Docket No. 50-277

1. Order for Modification of License
2. Safety Evaluation of Mechanical Plugs to be Inserted into the Bypass Holes of the Peach Bottom Atomic Power Station Unit 2
3. Safety Evaluation of Mechanical Plugs to be Inserted into the Bypass Holes of the Duane Arnold Energy Center Reactor
4. Safety Evaluation of Mechanical Plugs to be Inserted into the Bypass Holes of the Vermont Yankee Nuclear Power Station

SAFETY EVALUATION OF MECHANICAL PLUGS TO BE INSERTED INTO THE BYPASS

HOLES OF PEACH BOTTOM ATOMIC POWER STATION UNIT 2

Figure 1. Plug Installed in Core Plate

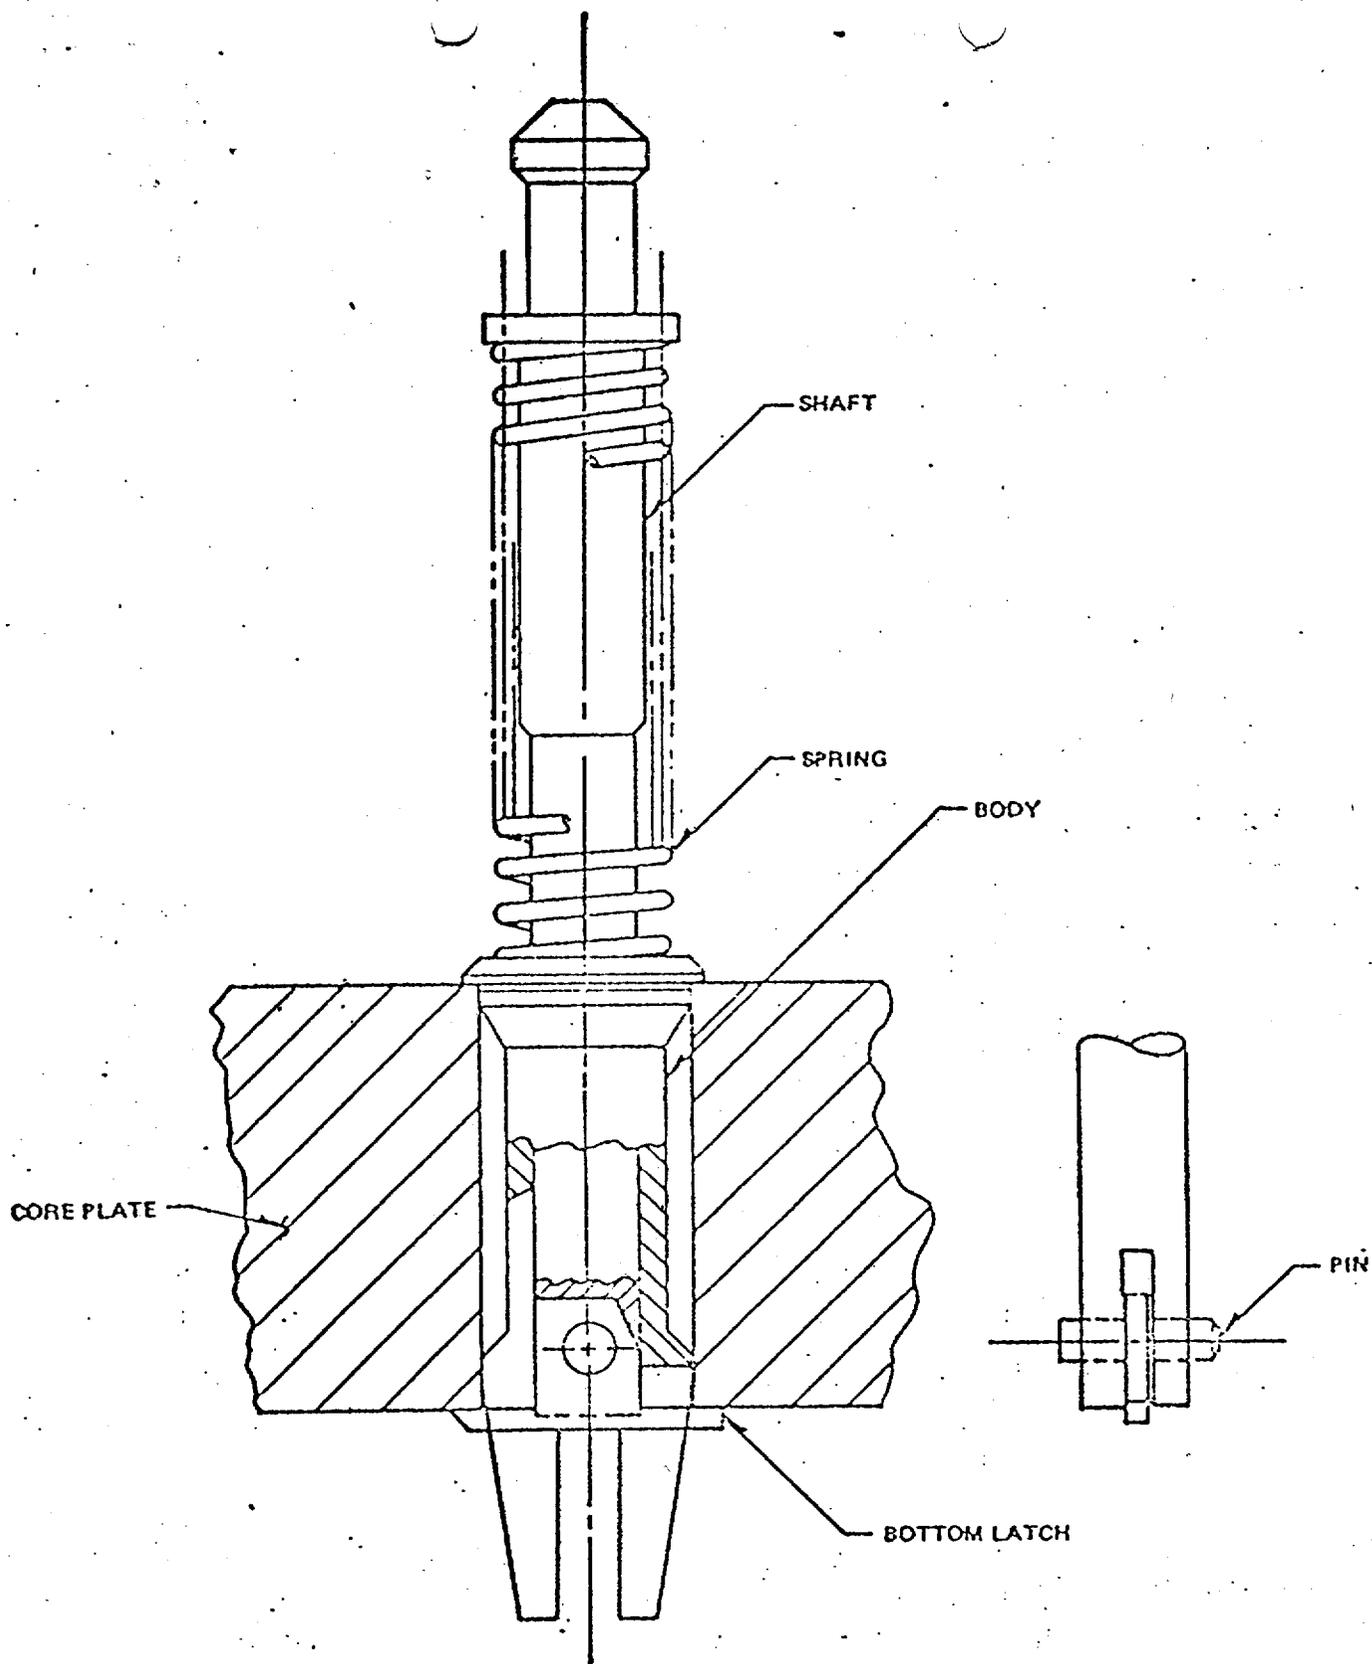
The plug consists of five basic parts, as shown in Figure 1. Identical plugs have previously been installed at Vermont Yankee, Pilgrim, and Duane Arnold. The body provides a means of guiding the device into the bypass flow holes as well as a shoulder to support the plug and form a seal against water flow. The shaft extends through the body. A knob is provided at the top of the shaft to provide a means of grabbing the plug during installation and extraction. At the bottom, the latch is attached to the shaft by a pin. The latch is free to rotate during installation. The spring acts against the body and shaft during normal operation to provide the force necessary to offset the pressure differential acting on the body.

During installation, the plug has its latch rotated 90 degrees from its installed position and withdrawn and locked in the body. The shaft is gripped by the installation tool, and the plug is inserted into the bypass flow holes. The body engages the rim of the hole. The shaft is pushed to its full extension, thus lowering and unlocking the latch below the underside of the core plate. The latch then rotates 90 degrees and bears on the bottom of the core plate. After insertion, the plug is pulled with about 30-pound force to test the placement.

The plug can be removed by gripping the top of the shaft with an extracting tool and applying a force of about 500 pounds. The latch's legs will be plastically deformed and the entire plug withdrawn. The plugs previously installed at Vermont Yankee were removed with no abnormalities or loose pieces reported. The force required for removal varied from 500 to 1300 pounds.

Based on a review of the design, the test rig, the installation methods and the previously successful operating experience at Vermont Yankee, Pilgrim, and Duane Arnold, we conclude that the plugs will not fail so as to result in loose parts in the core or result in unplugging of the bypass flow holes. Also, we conclude that the installed plugs will preclude unacceptable channel box damage for at least the proposed fuel cycle. Surveillance programs will be required to confirm the nature and extent of any residual tube excitation and resultant effect, if any, on core components.

A correlation between BWR channel box wear and lower core plate bypass flow holes has led to the development of a mechanical plug to fill these holes (Figure 1).

The core plate plug consists of two stainless steel parts (body and shaft) which are connected by an Inconel spring. The shoulder of the body rests on the top of the core plate along the rim of a one-inch bypass hole and is pressed down by the spring. An equal and opposite force is applied on the shaft. A stainless steel latch is connected to the bottom of the shaft by means of a pin. This latch is free to rotate about the pin and latches the shaft to the core plate. The spring exerts a minimum load of 33 lbs on the body and latch and a maximum of 46 lbs (with the worst tolerance combination).

The plug consists of five basic parts, as shown in Figure 1. Identical plugs have previously been installed at Vermont Yankee, Pilgrim, and Duane Arnold. The body provides a means of guiding the device into the bypass flow holes as well as a shoulder to support the plug and form a seal against water flow. The shaft extends through the body. A knob is provided at the top of the shaft to provide a means of grabbing the plug during installation and extraction. At the bottom, the latch is attached to the shaft by a pin. The latch is free to rotate during installation. The spring acts against the body and shaft during normal operation to provide the force necessary to offset the pressure differential acting on the body.

Accordingly, we conclude that the installation of the plugs should be authorized. Operation with plugged bypass holes is still under review.
